STAFF REPORT

To: Edgerton Planning Commission
Fr: Kenneth Cook, AICP, CFM, Community Development Director
Re: Application FS2016-07 for Final Site Plan for Inland Port VIII, located East of Waverly Rd and South of 183rd Street

Requested Action: Final Site Plan – Logistics Park Phase VI, Lot 1
Inland Port VIII

Sheet
C03

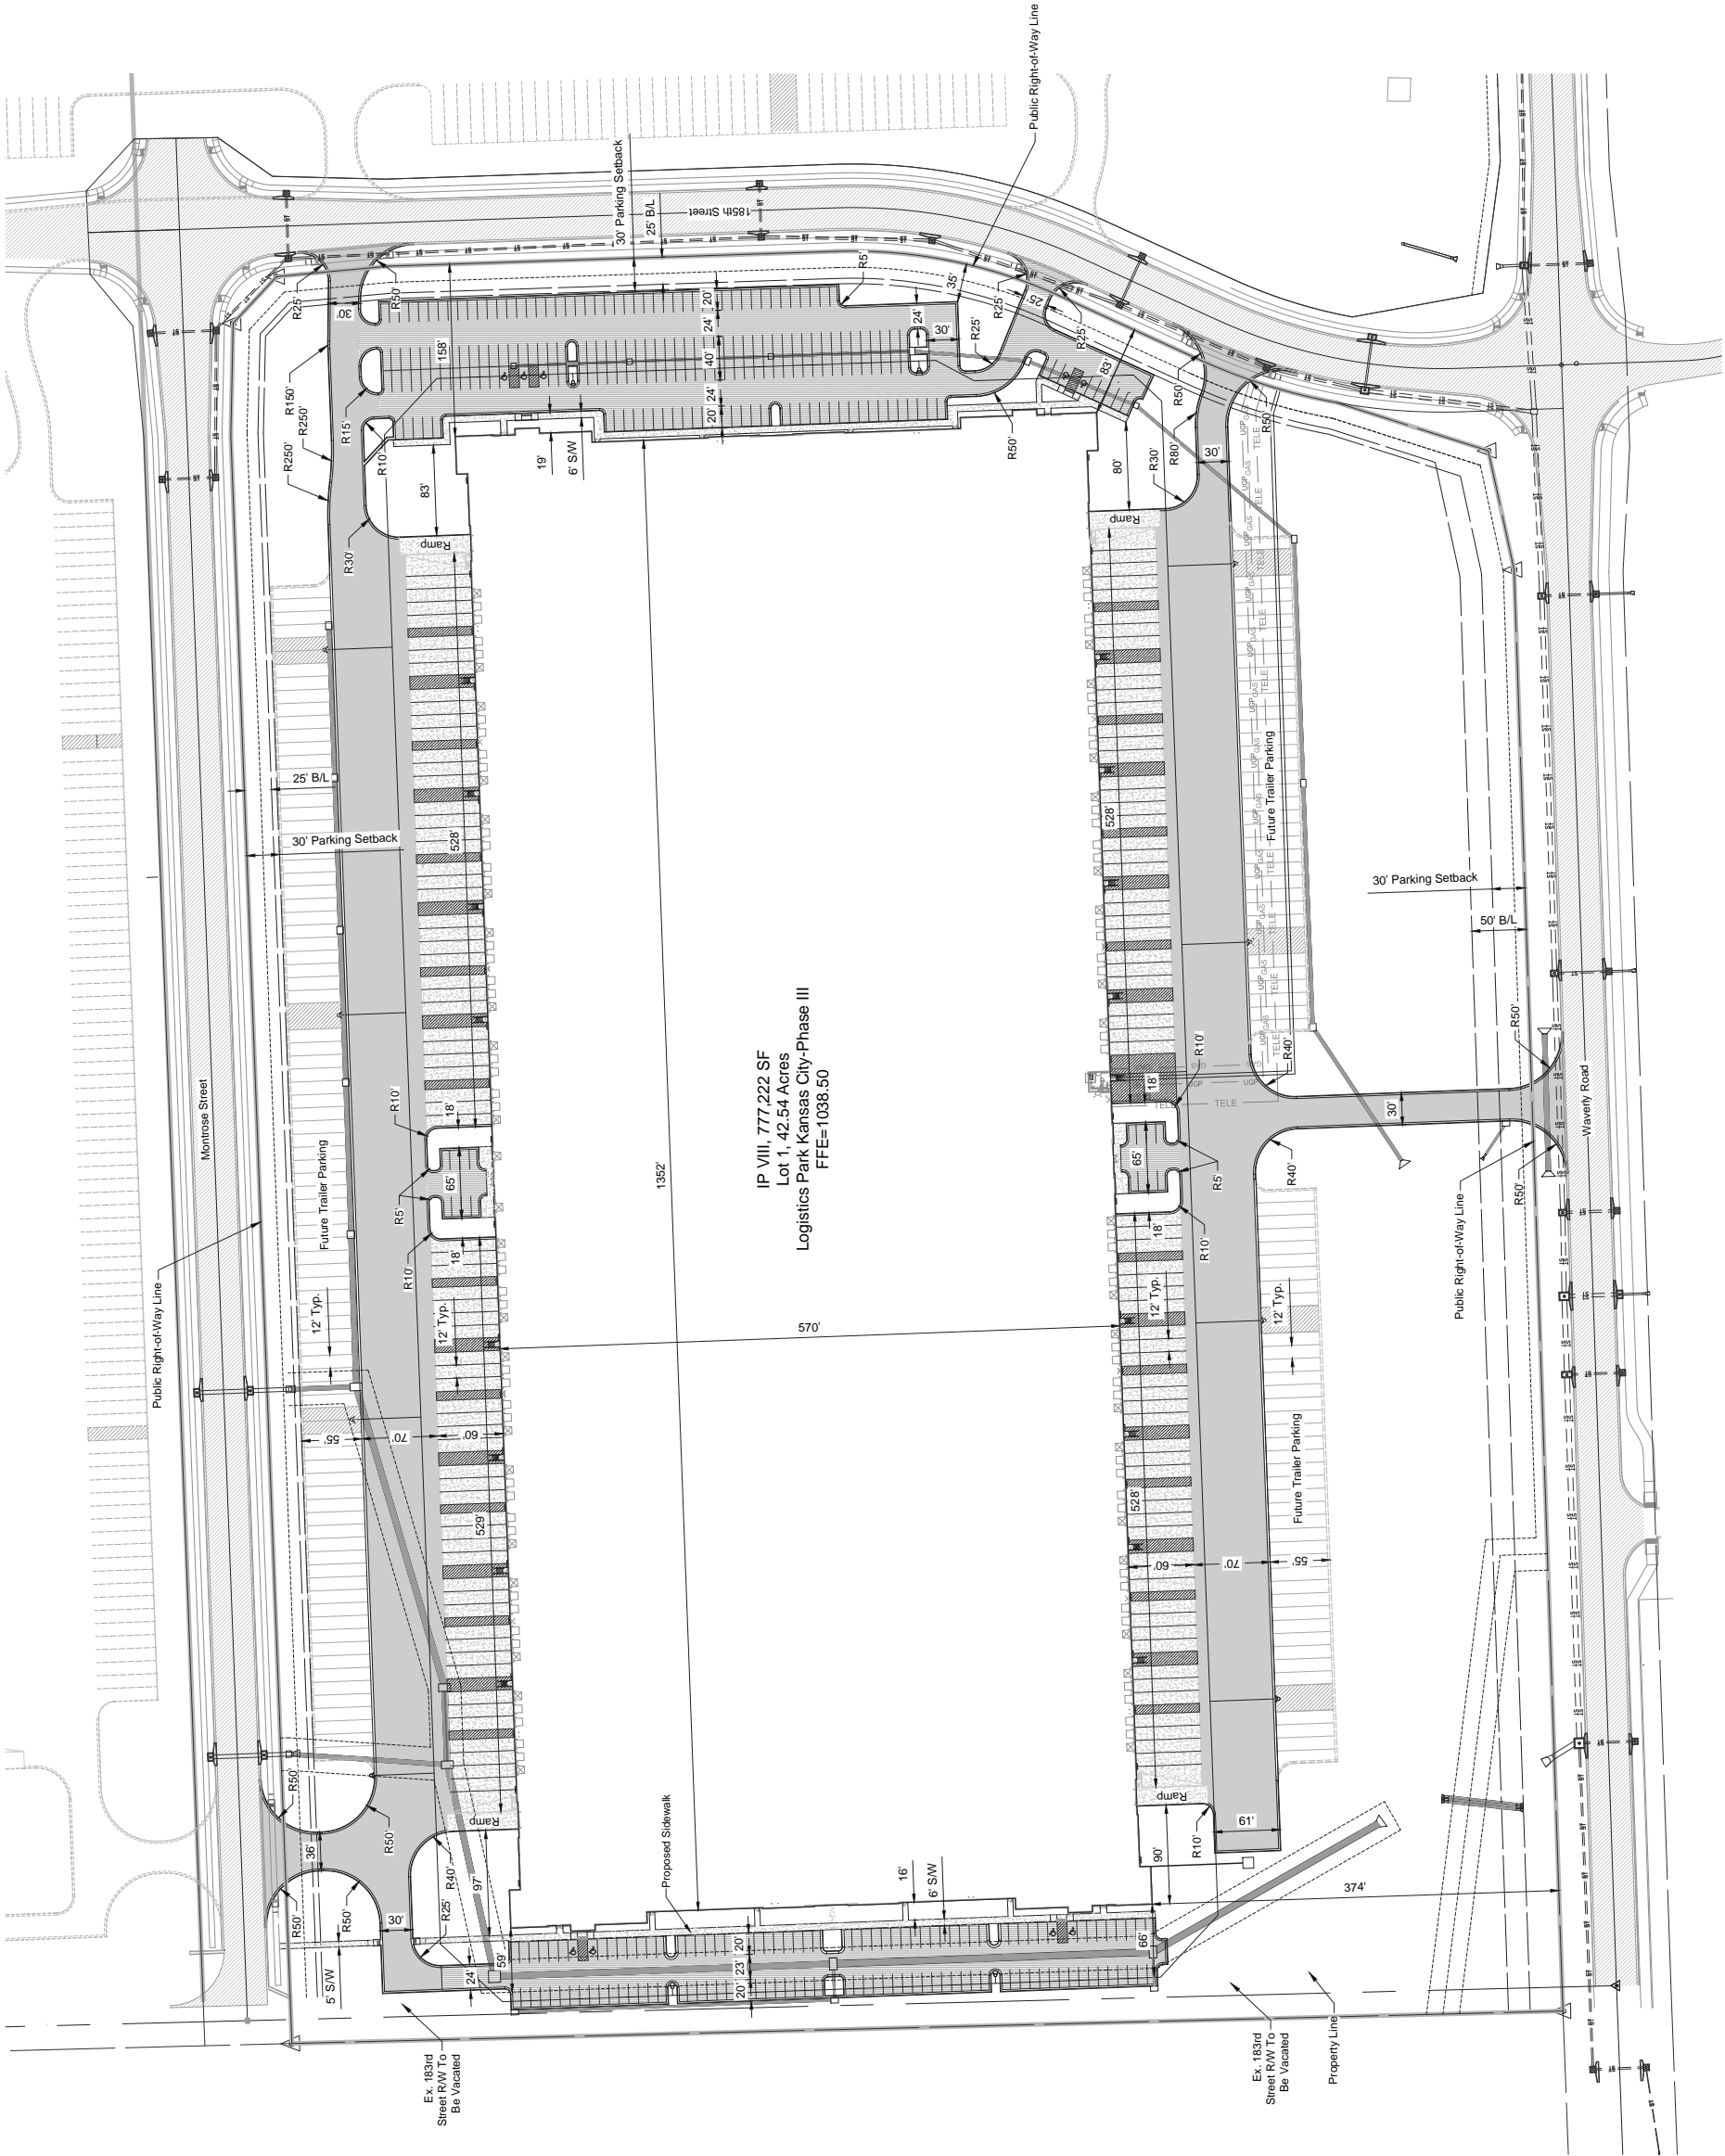
- ii) Exterior lot lines with any survey pins. ***Final Site Plan does not show any survey pins.***
 - iii) Location of buildings. ***Final Site Plan complies.***

- iv) Parking areas, paths, walks with sizes and surfaces material specifications. *Sidewalks need to be provided from the South side of the building to the public Sidewalk. Need to check with the Fire Department to determine if a turnaround is required at the West end of the North parking lot. Concrete driveway aprons are required. **Final Site Plan complies.***

- vi) Site entrance and connections to streets. *Original site plan had shown slightly different location for entrances. The applicant worked with City Staff to coordinate the location of entrances with other existing and proposed entrances. **Update Final Site Plan.***

- vii) The location of easements. *Drainage easements should encompass the detention pond and outlet pipe to the existing permanent easement. Label the existing permanent easement in the Northwest corner of the property. **Update Final Site Plan.***

Preliminary Storm Plan

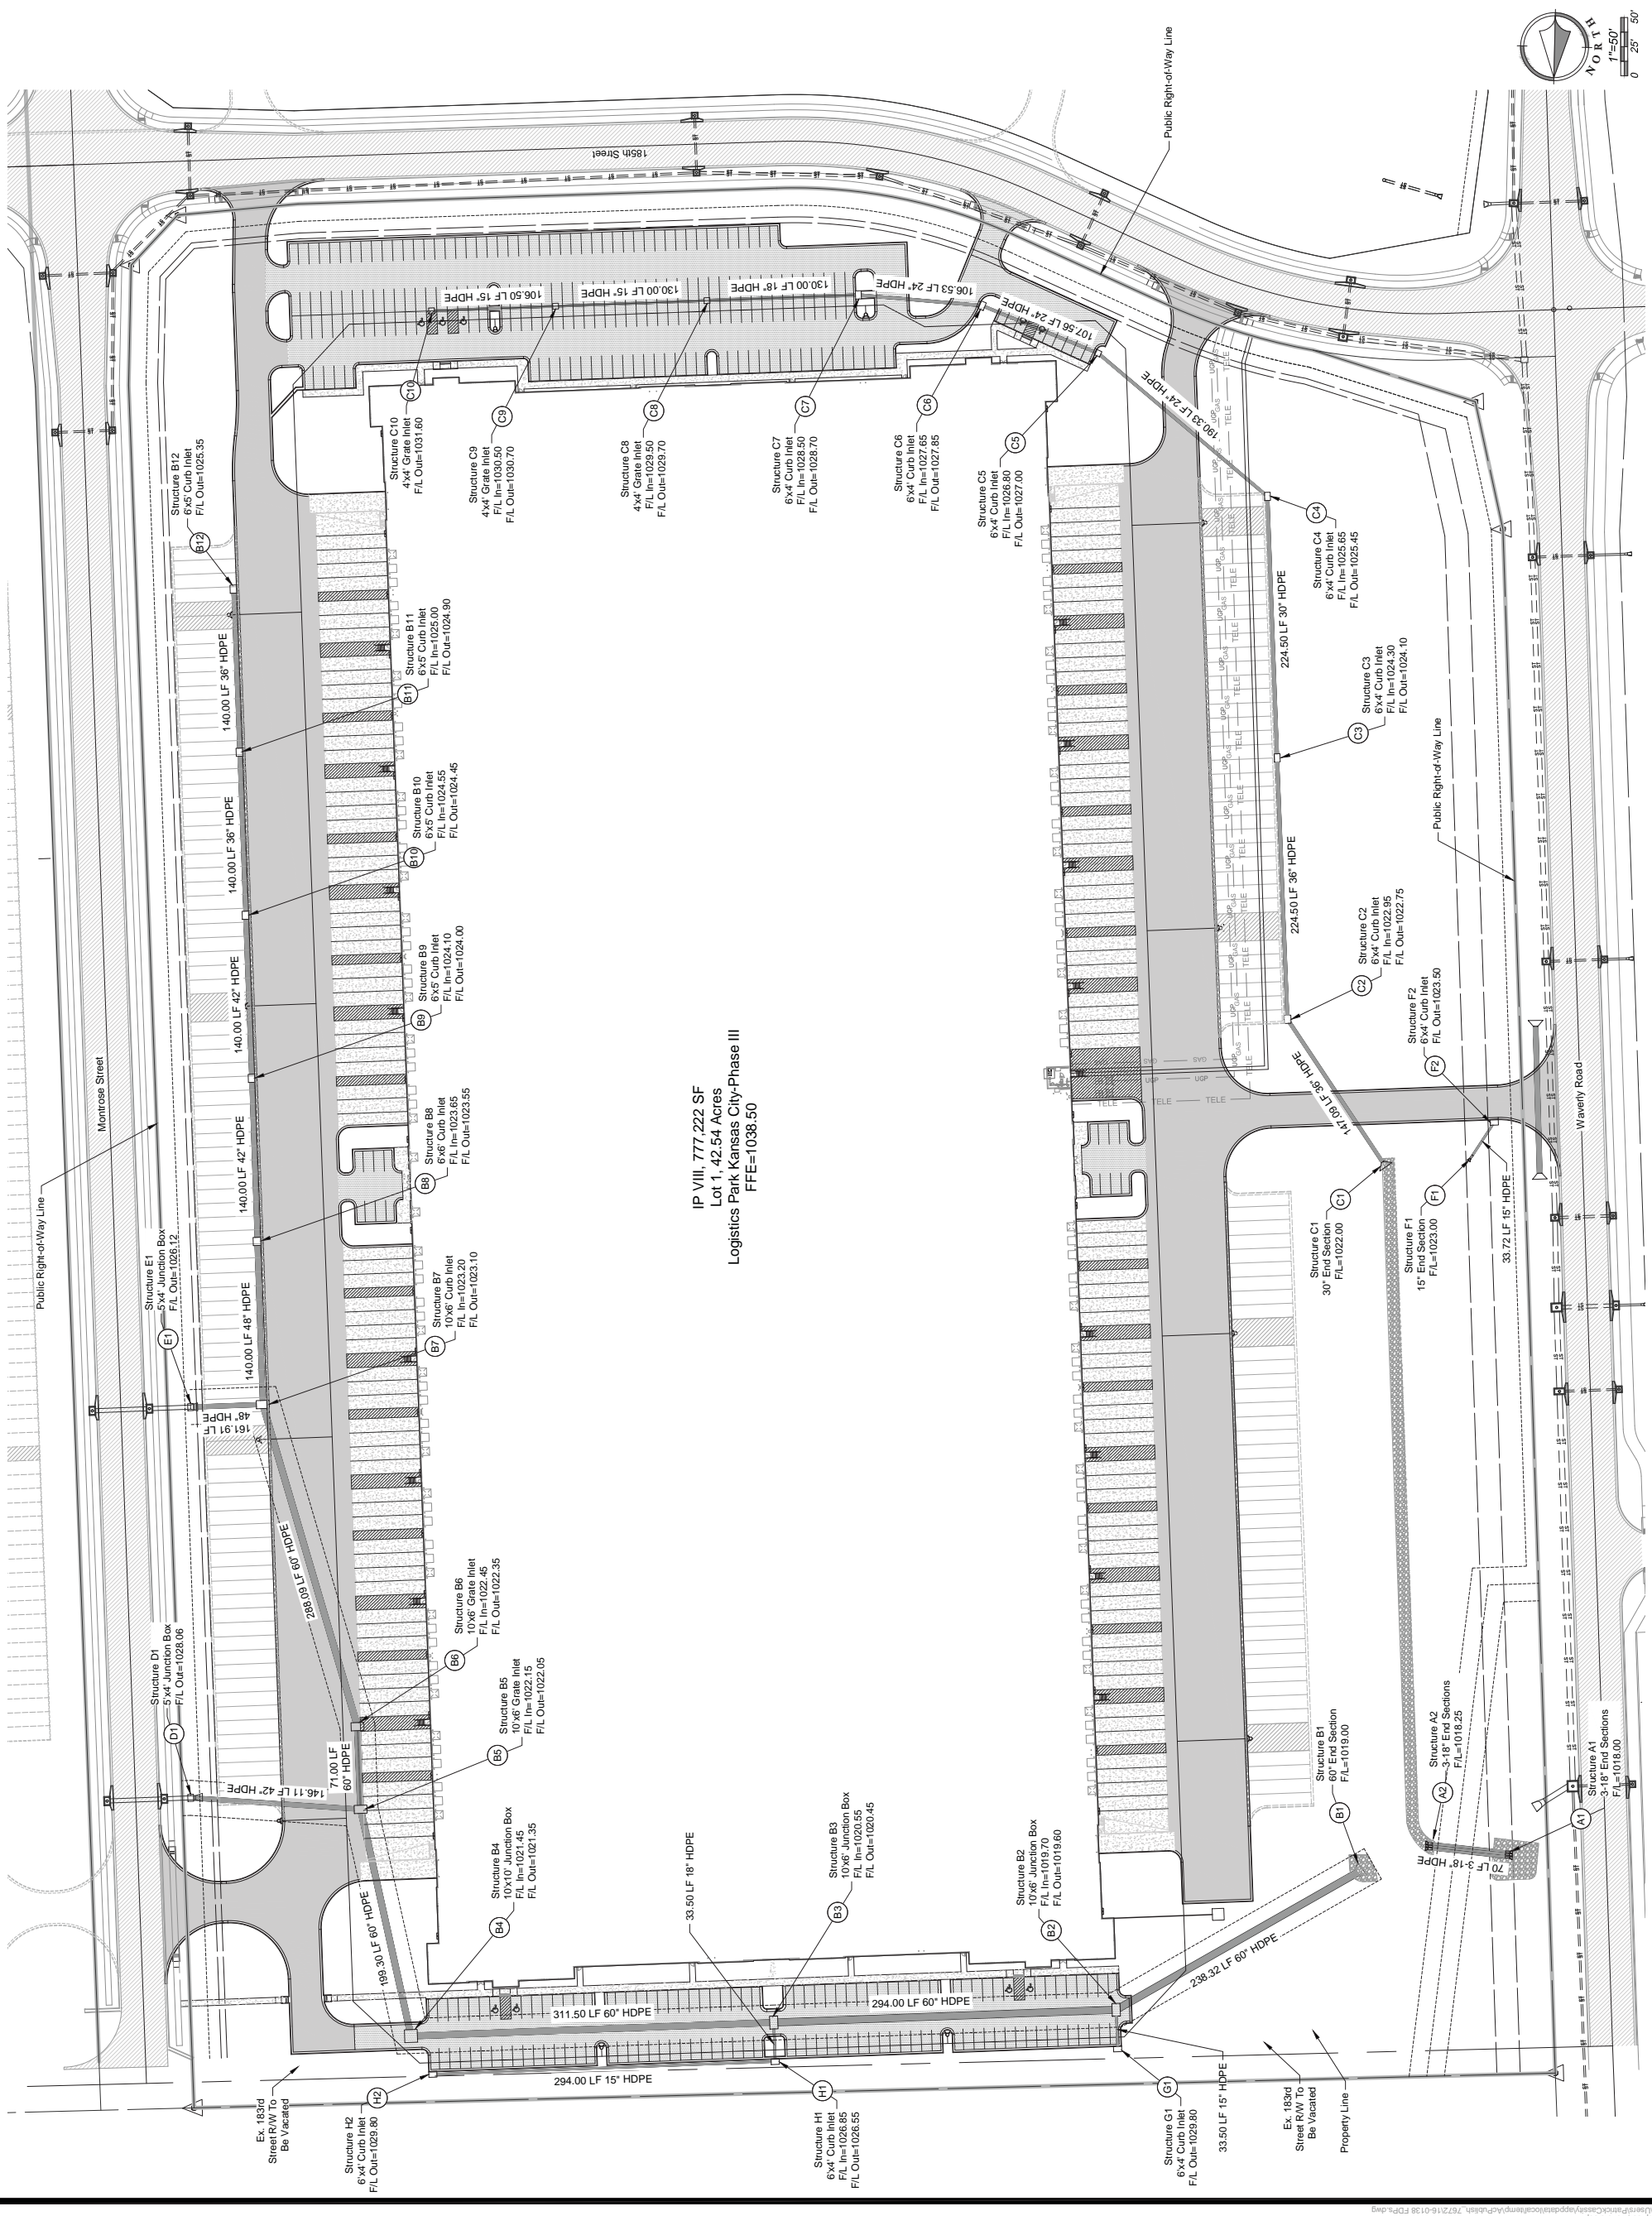
1. A storm water study has not been submitted.
2. Provide the velocity in a 1 year storm in the table on Sheet C06. The velocity should be greater than 3.0 ft/sec
